MEETING AGENDA

CITY PLAN COMMISSION Wednesday, February 23, 2022 Work Session 12:30 p.m. Public Hearing: 1:30 p.m.

PP-21-100 Eagles Crossing, Lots1-2, 3X, 4-31, Block 1; Lots 1-44, Block 2; Lots 1-44, Block 3; Lots 1-44, Block 4; Lots 1-9, Block 5; Lots 1-3, 4X, 5-27, 37X, Block 6 (Waiver Request/Conditional Approval): 195 Single-Family Detached Residential Lots, 1 Multi-Family Lot, 1 Gas Well Pad Lot and 5 Private HOA Open Space Lots. Council District 6.

Case: PP-21-100	Remarks Due:
Submitted: 12/8/2021	ZC Hearing:
	Case Status: In Revi
Title: Eagles Crossing

PP-22-001

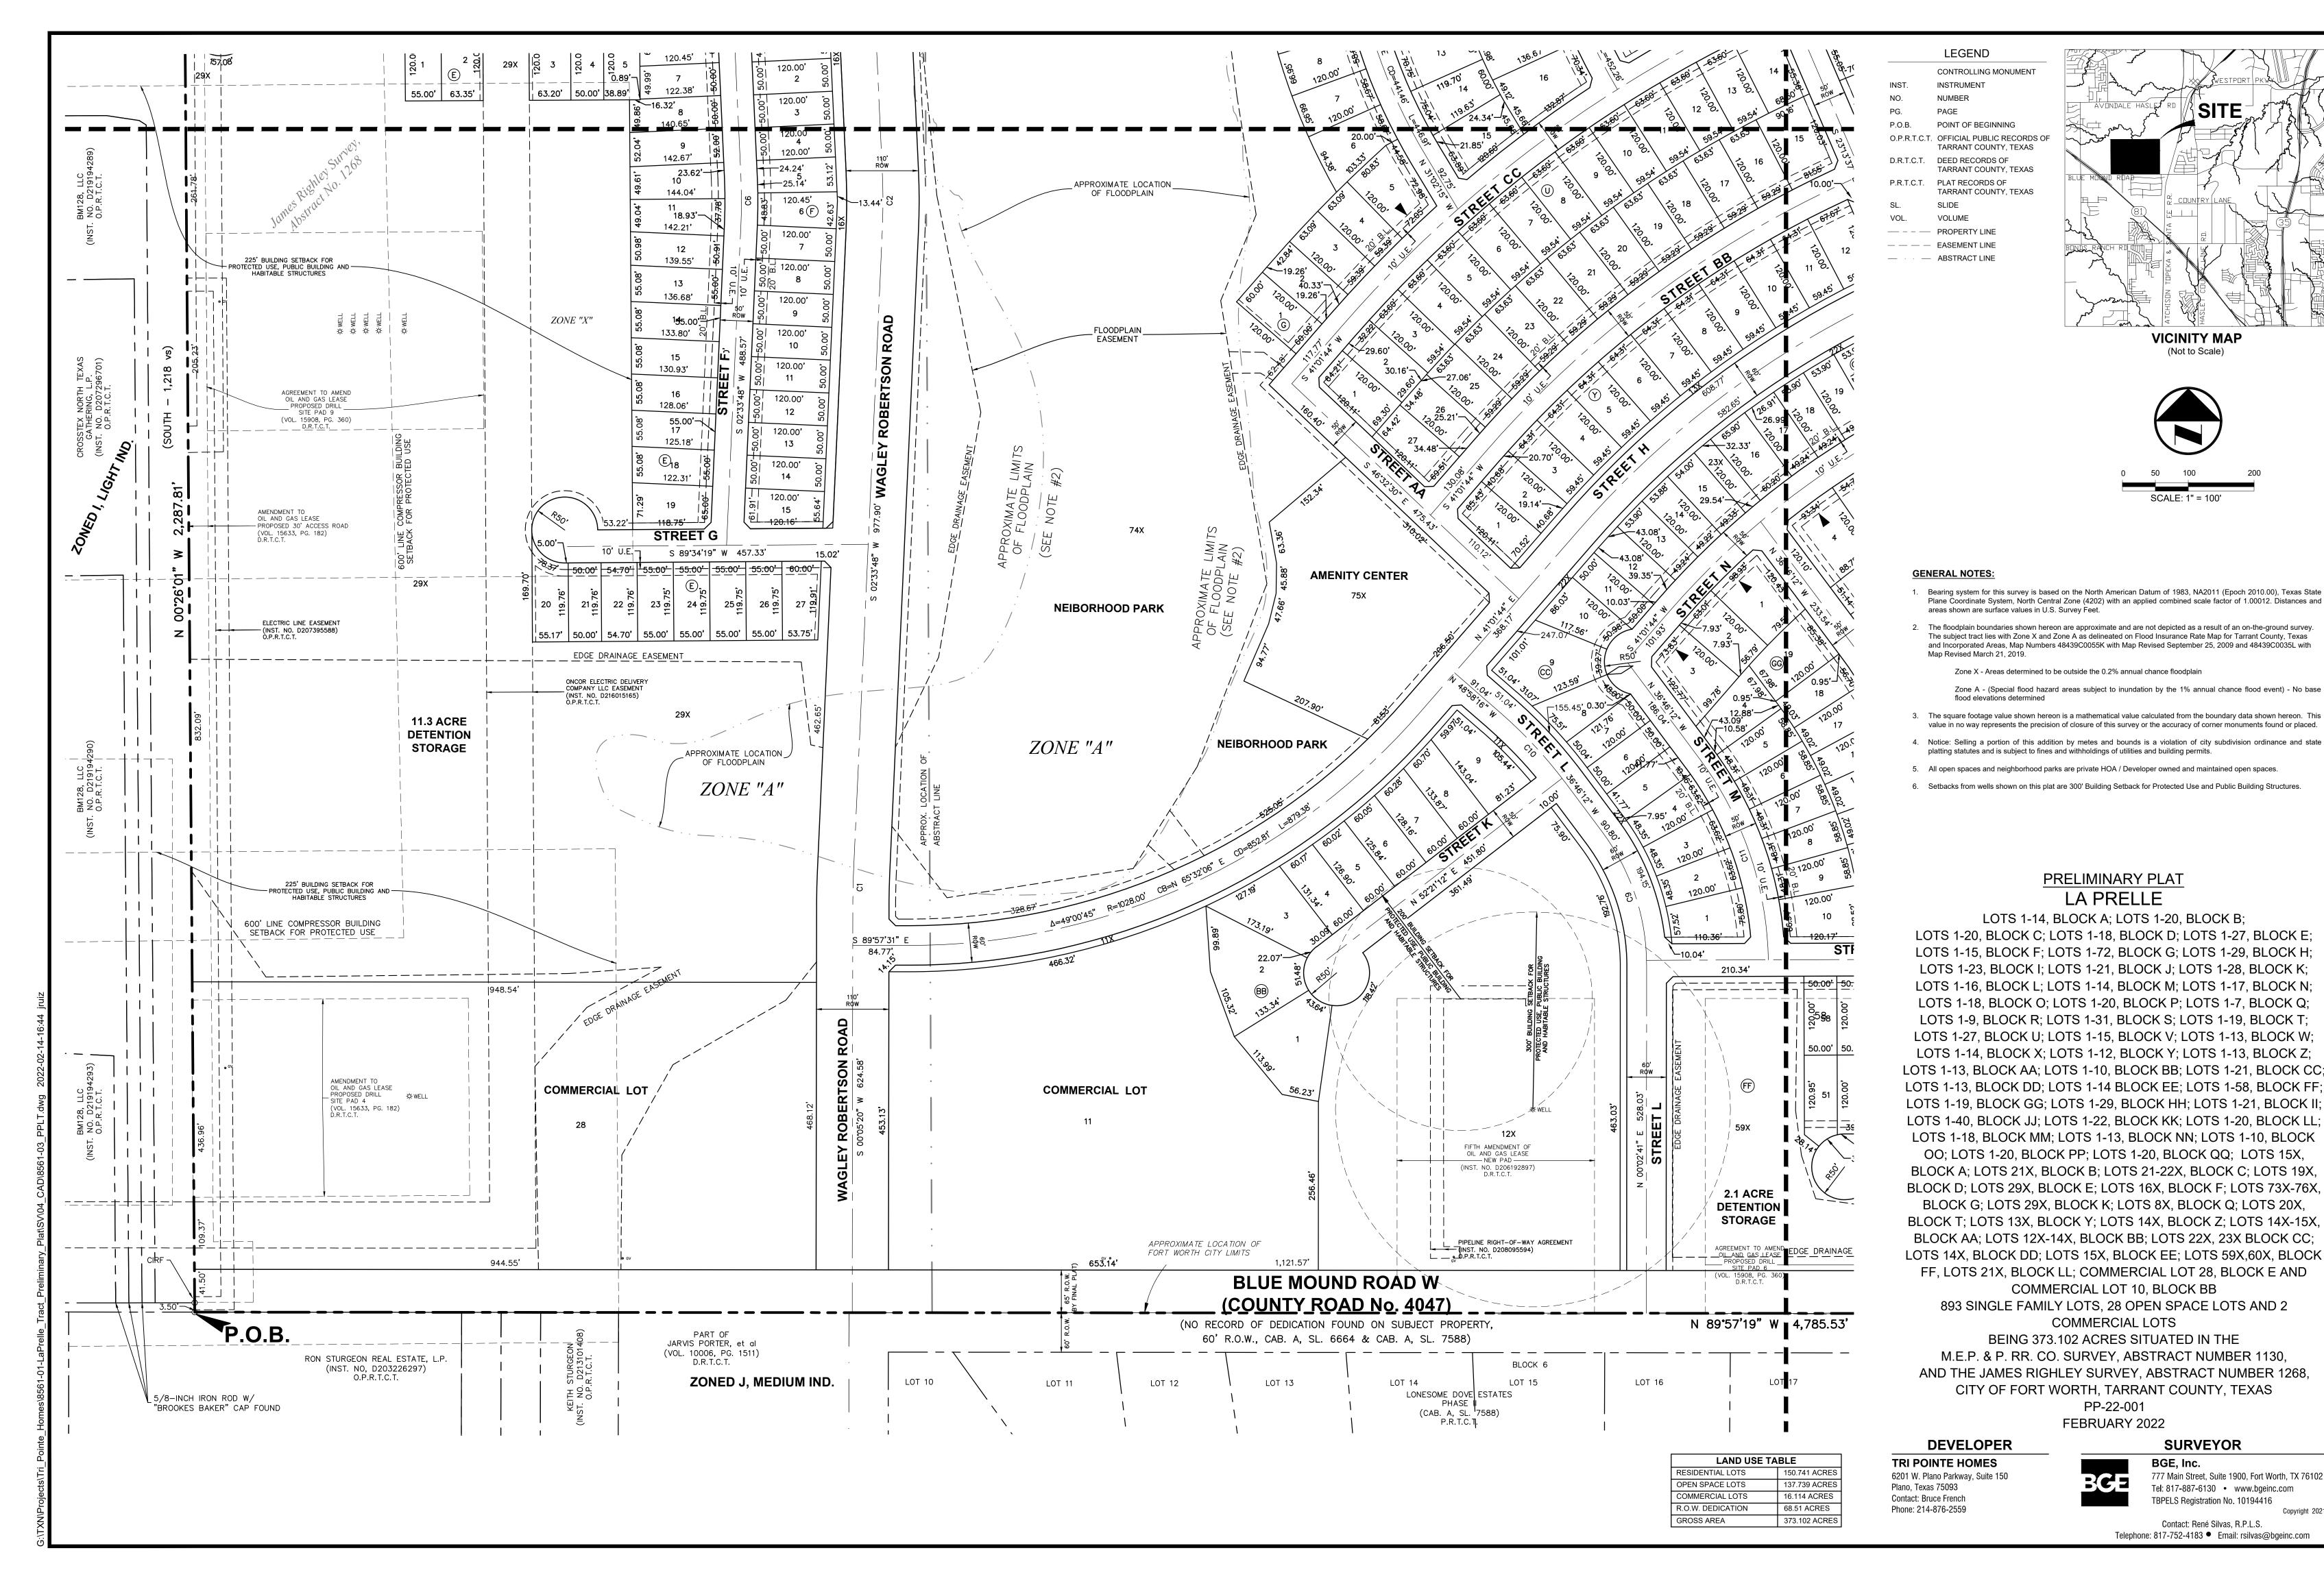
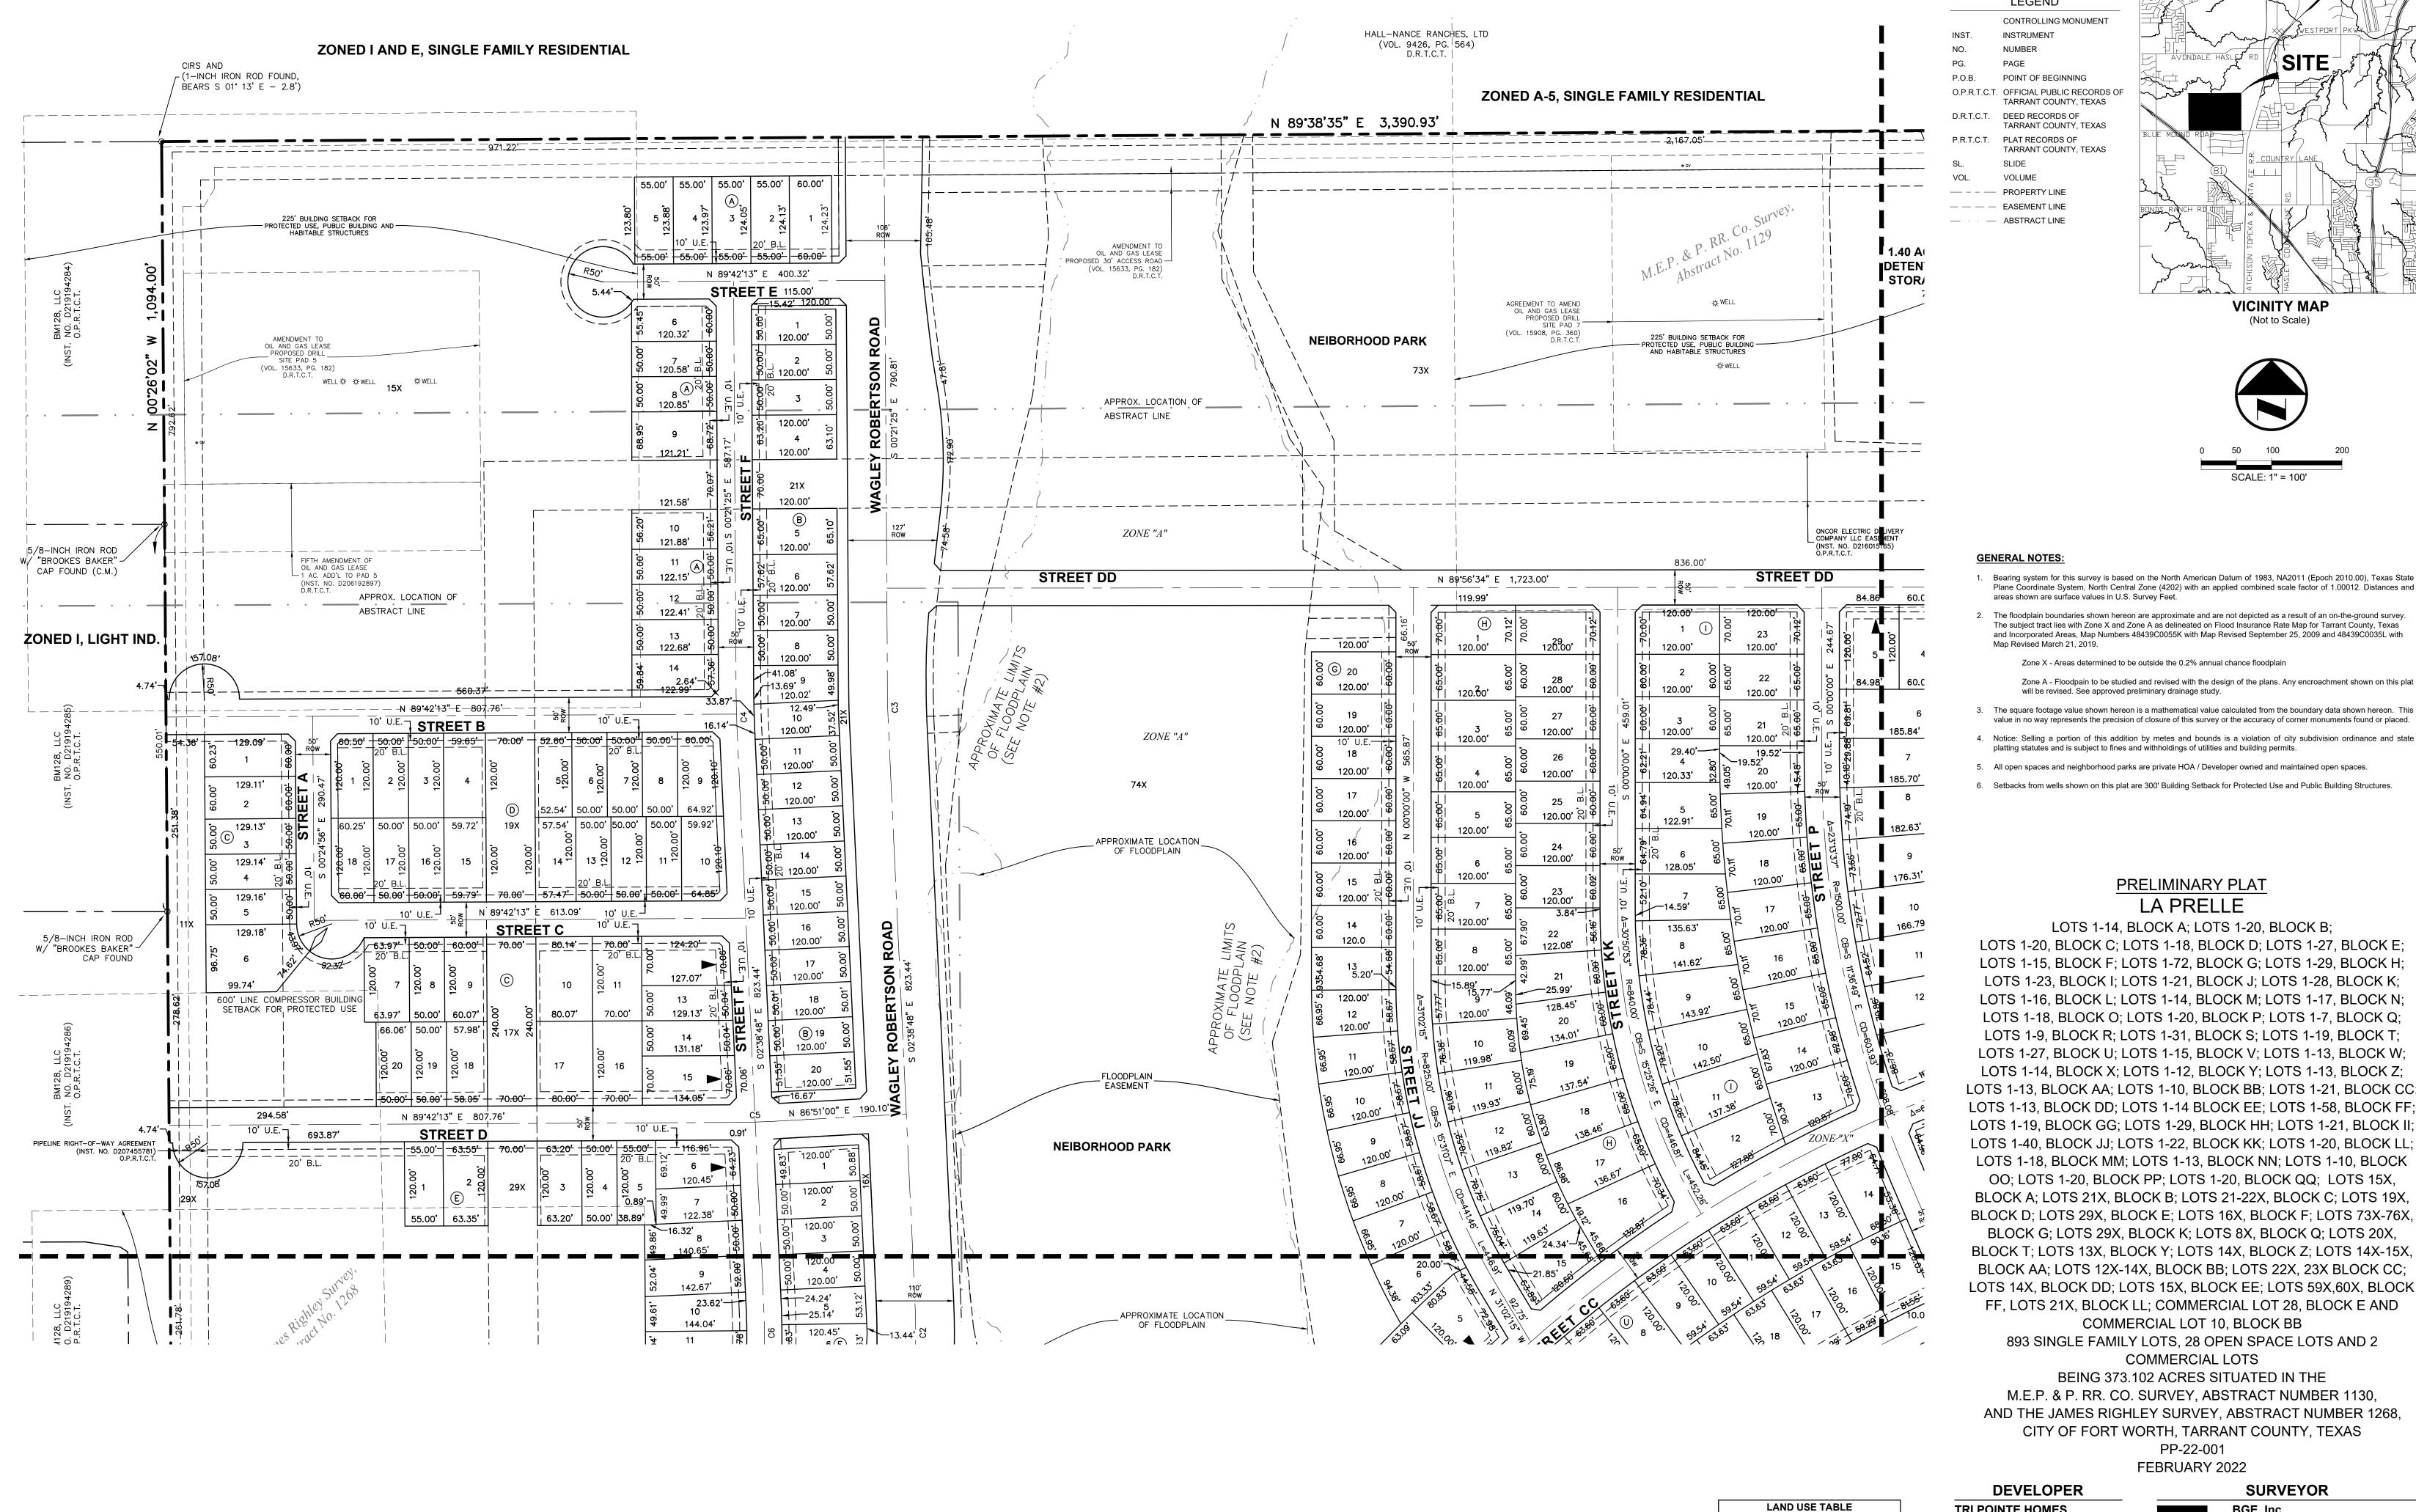
Need to show and label gas well and lift compressor setbacks: the setbacks for the gas well sites on Blue Mound Rd W need to be measured from the well bores: 300' for protected uses and public buildings and 200' for habitable structures - the lift compressor setback is measured from the center of the lift compressor or spotted location: 200' for protected uses, public buildings, and habitable structures.

Correct Blue Mound Road to Blue Mound Road W

Provide copy of special warranty deed to TPHMI DFW 4047 LLC to document ownership of the three tracts combined for the 373.102 acres preliminary plat.

MTP roadways Wagley Robertson- Neighborhood Connector [NCO-L2-T0-NTMS-P0-BOP (110)] 110-foot ROW (Proposed Street I) and John Day - Neighborhood Connector [NCO-L2-T0-NTMS-P0-BOP (110)] 1110-foot ROW. Verify location, dedication requirement, specifics with TPW Transportation.

Subdivision Ordinance, Section 31-102(b)(2) Interconnectivity of Neighborhoods. Fragmented street systems impede emergency access and increase the number and length of individual trips. New residential subdivisions shall be designed to coordinate with existing, proposed and anticipated streets. Local and collector streets shall be extended to the tract boundary to provide future connection with adjoining un-platted lands. Street extensions are required to the unplatted tracts to the north (Nance Tract) and west. Stubout not provided through Open space Lot 34X. A project redesign or CPC approval of waiver request is required.

- 1. (Records Management and Real Property) Variable ROW Show the full ROW widths for all existing streets. For streets having variable ROW, call out the ROW as "Variable" and give "Range" of the ROW. Show the right-of-way width for John Day Road. CLEARED 02/10/2022 AB.
- 2. Label Plat Show Case Number on the plat. (But not as part of title block). CLEARED 02/10/2022 AB.
- 3. Plat shows that John Day Road is located in Haslet. However Haslet GIS map states differently. Confirm location of John Day Road

- Contact: sds@fortworthtexas.gov
- 1. Show connecting line callout out for proposed Floodplain Easement to both sides of Floodplain with a centered label & reference study for Floodplain Easement.
- 2. Show connecting line callout to both sides of the FEMA Effective Floodplain per the FEMA NFHL Map and label the effective FIRM Panel and Effective Date on plat face.
- 3. Label all detention pond drainage easements seen on Lot 8X, 34X, 59X, & 76X and show storage in ac-ft. Reference Sheet 36, Preliminary Storm Layout in DS-21-0144.
- 4. Show all proposed storm outfall drainage easements per Sheet 19 D.A.M. & Sheet 36, Preliminary Storm Layout in DS-21-0144.
- 5. Show Drainage Easements for Blue Mound Rd as seen Sheet 36, Preliminary Storm Layout in DS-21-0144.

3- Provide adequate water/sewer exclusive easements to match city accepted construction plans per the Installation Policy and Design Criteria for Water, Wastewater, and Reclaimed Water Infrastructure May 2019. Offsite easements and or easements by separate instrument need to have recording information shown on plat before hold can be cleared. Plat will be reconciled with reviewed and accepted plans to make sure all easement are correct before hold can be cleared.
